FAIRFAX COUNTY, VIRGINIA

MEMORANDUM

SUBJECT: Staff Analysis of Conceptual Plan 86-C-121-10: CareMatrix of
Massachusetts, Inc.

Title of CP: Chancellor Park at Reston, Section 95 Block 1
Prepared by: Urban Engineering and Associates, Inc.
Dates: September 1997 revised to March 20, 1998

SHEET
2
OF
8

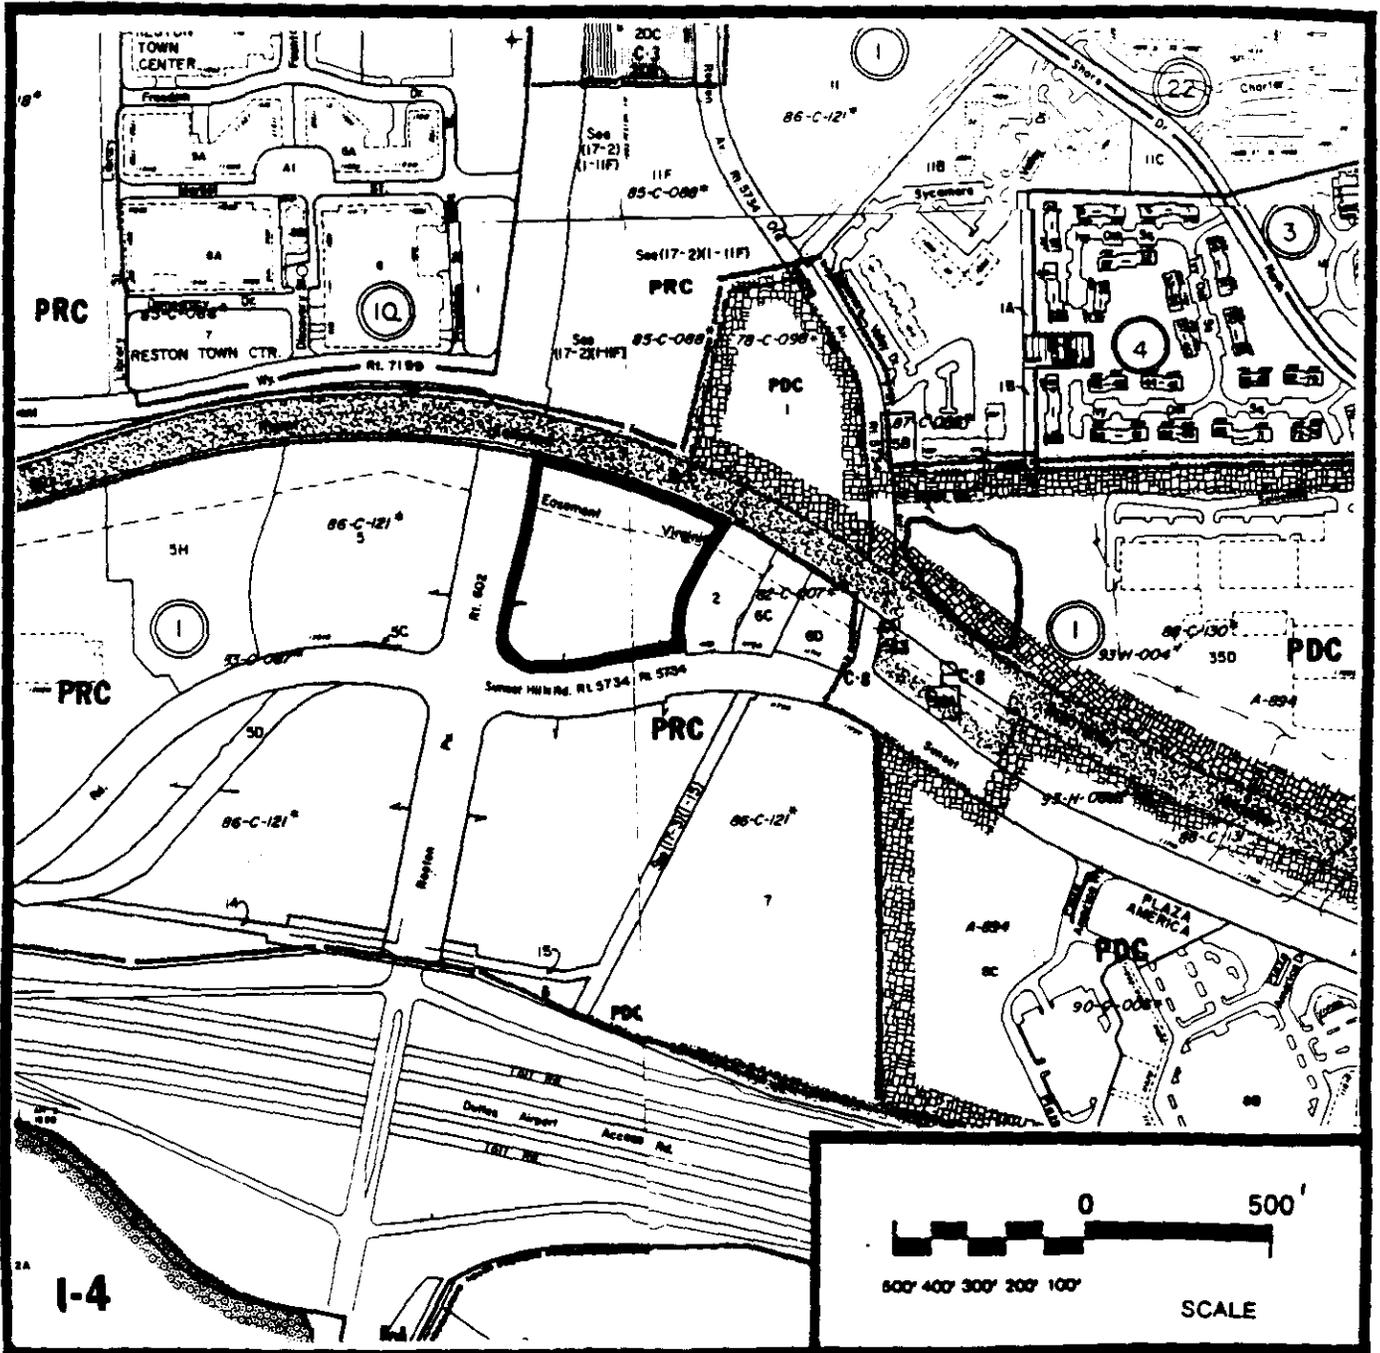
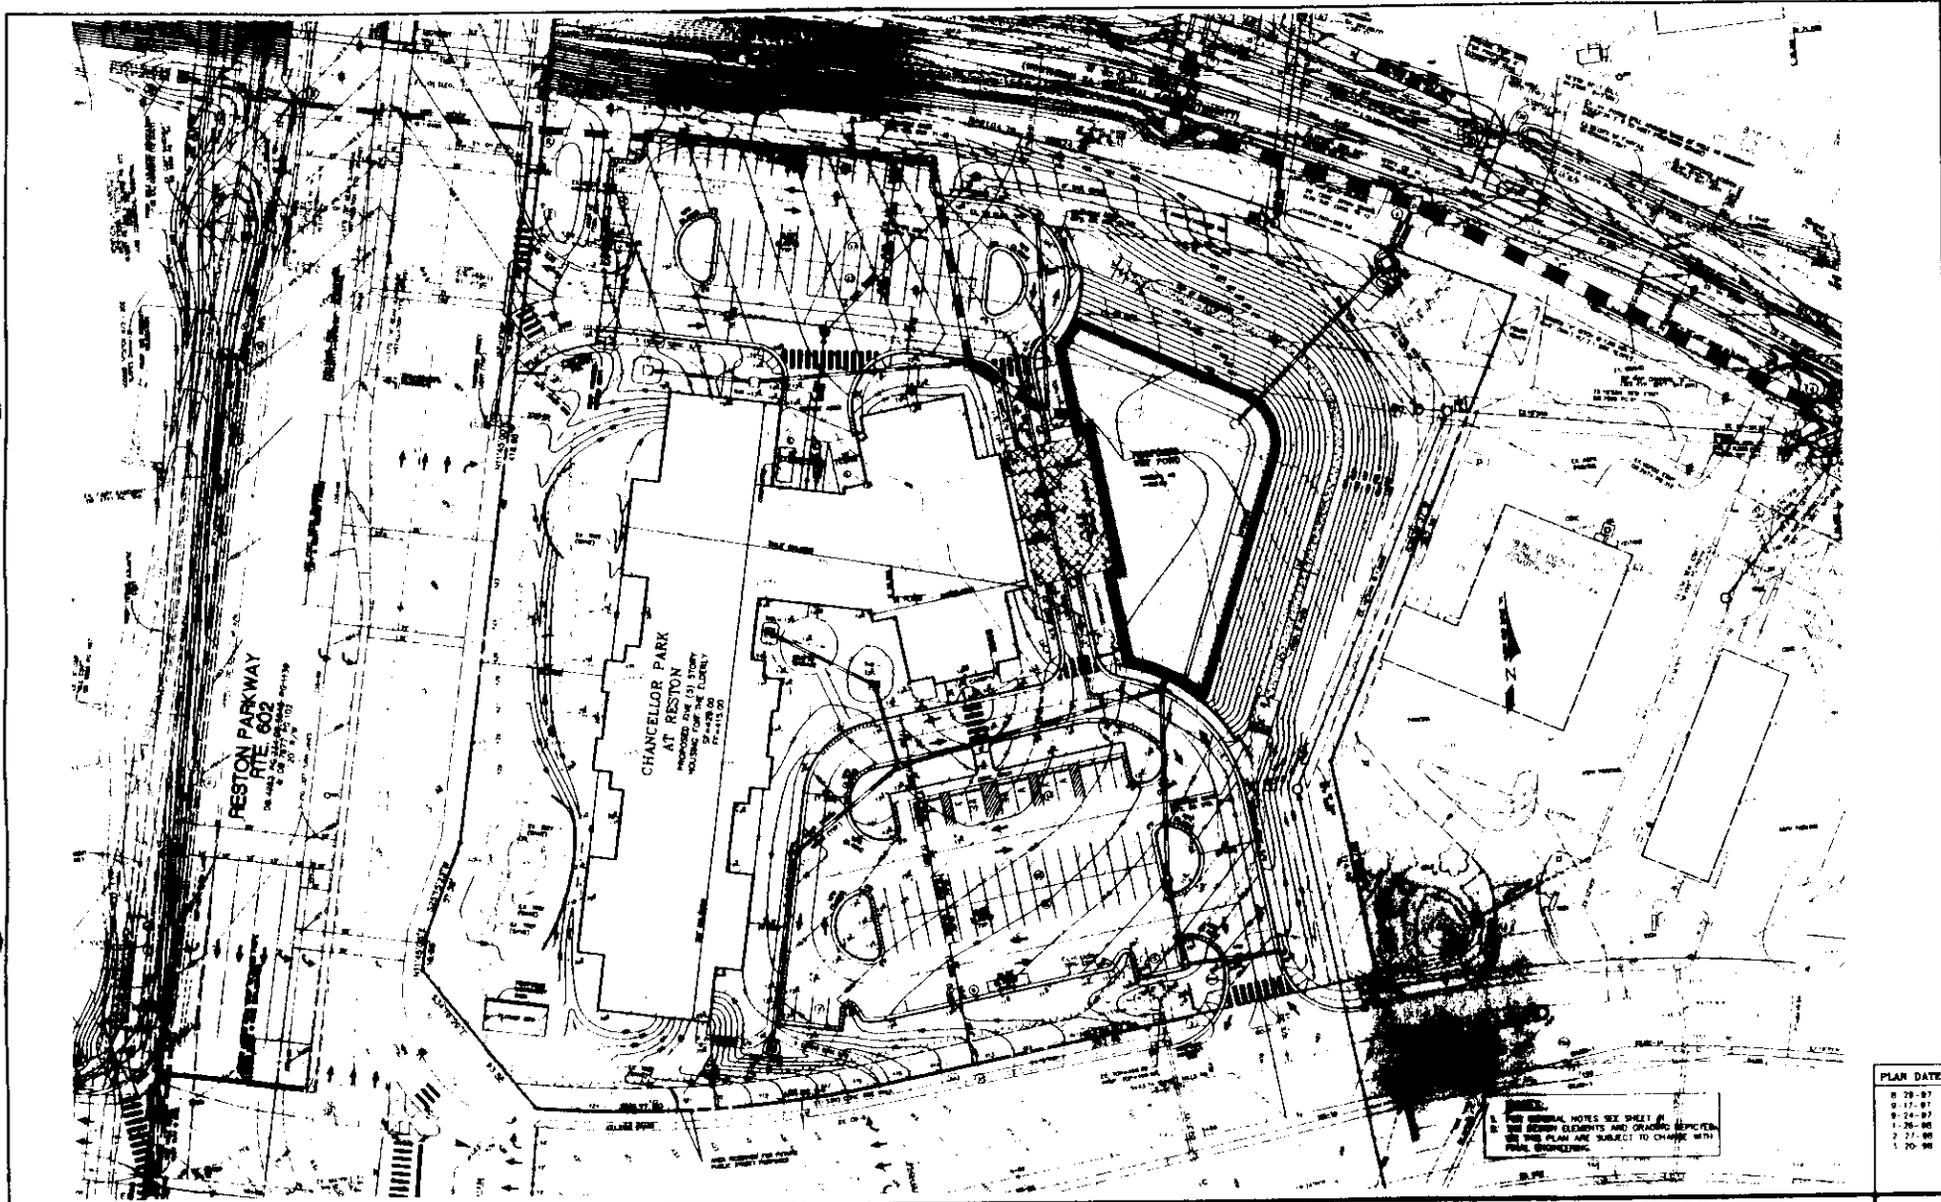
Stormwater Management: The stormwater management pond which is depicted on the Conceptual Plan is very large and its construction will cause the removal of a substantial number of trees on the site. Staff requested that the applicant look at less land intensive alternatives for Stormwater Management and Best Management Practices on the site. The applicant has indicated that the wet pond was required as part of the Sunset Hills Road and Reston Parkway improvement projects. The applicant has designed the wet pond to be an

Pedestrian Access: Initially, the CP did not clearly show the 8 foot wide asphalt trail along Reston Parkway connecting to the existing trail to the north. The applicant was requested to revise the CP to show this connection. The CP has been revised to show this connection.

There are site design issues related to the open space areas along Sunset Hills Road and Reston Parkway. As previously discussed in the Transportation Analysis section of this report, the applicant has been requested to dedicate an additional 12 feet of right-of-way for a future right turn lane along the Sunset Hills Road frontage of the site. The previous submission of the Concept Plan showed a landscaped open space area ranging in width from 25 feet west of the site entrance on Sunset Hills Road parallel to the proposed parking lot to 50 feet in width near the intersection of Sunset Hills Road and Reston Parkway. This area will be reduced by 12 feet with the future dedication which impacts the streetscaping along Sunset Hills Road and also reduces the building setback to 33 feet. Staff recommended that the applicant to shift the building and parking area to the north to provide for a minimum streetscaping width consistent with

In an effort to address this issue, the applicant has converted the head-in parking located perpendicular to Sunset Hills Road to parallel parking which increased the open space area to 20 feet excluding the 12 feet of additional dedication. The landscaping has been pulled out of the 12 foot dedication area and placed closer to the parking area. A shrub type hedge has been added to buffer the parking area from Sunset Hills Road. It should be noted that the building setback will remain at 33 feet after dedication for the turn lane. While it would be desirable for the building setback to be increased, there are no required building setbacks in the PRC District. With the increased open space provided along Sunset Hills Road adjacent to the parking lot, the streetscaping along Sunset Hills Road is comparable to that approved with the other developments in the quadrant.

As discussed earlier in the Environmental Analysis of this report, very little in the way of tree preservation is proposed for this site. Given the prominent location of the site, as an entrance to the Town Center, staff believes that the highest quality landscaping be provided along Reston Parkway. The applicant has committed in the CP Notes to hire a certified arborist to conduct a pre-condition analysis of the trees identified to be preserved and to prepare a tree preservation plan. The applicant has also committed to identify and transplant certain trees, if feasible, within the landscaped areas shown on the CP. Other than landscaping, the only feature along the Reston Parkway frontage is the pedestrian trail which is proposed to link to the existing trail system to the north which includes the WO&D trail. The only amenity along this trail are two benches near the southern end of the Reston Parkway frontage. Staff believes that some type of plaza like feature with seating and some type of design element such as a landscaped planter or fountain would be desirable along this frontage and would continue the linear park concept provided along the Stratford at Town Center residential development to the north of this site. This would also provide a desirable pedestrian amenity for the residents of the CareMatrix facility; all of the site amenities for the facility have been oriented to the interior of the site. No such amenity has been shown on the CP.
